June 18, 2001
Project No. CRA102

Re: Workplan for Off-Site Characterization, Cargill Salt Alameda Facility

Cargill Salt Dispensing Systems Division
2016 Clement Avenue, Alameda, California
Figure 2. Previous Sampling Results

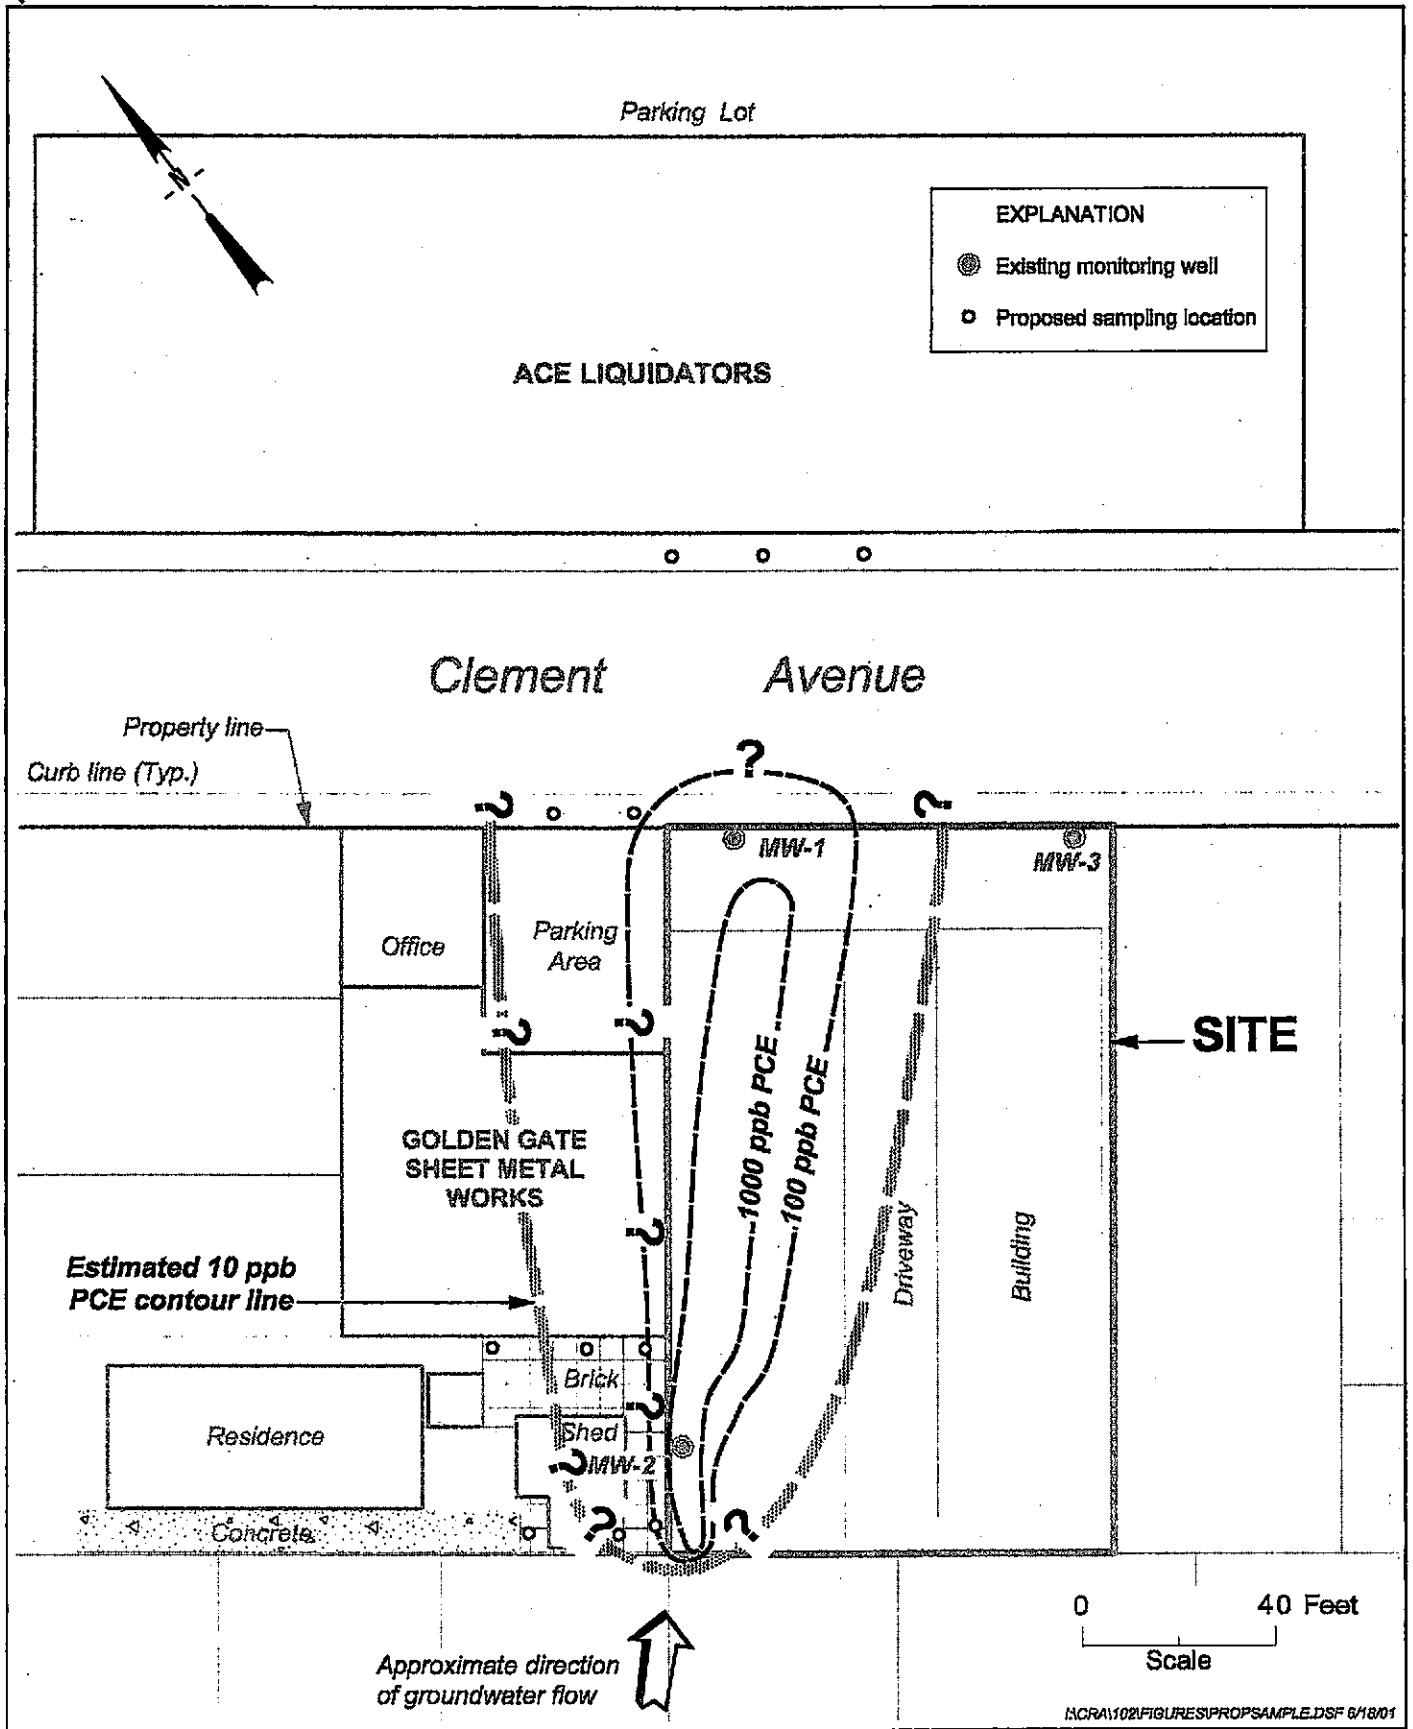
what about SB SSW of A68-1
Groundworks July 1995 rpt show
a SB was advanced ~ 2 feet upgrd
w/ much lower PCE in GW (22ppb)
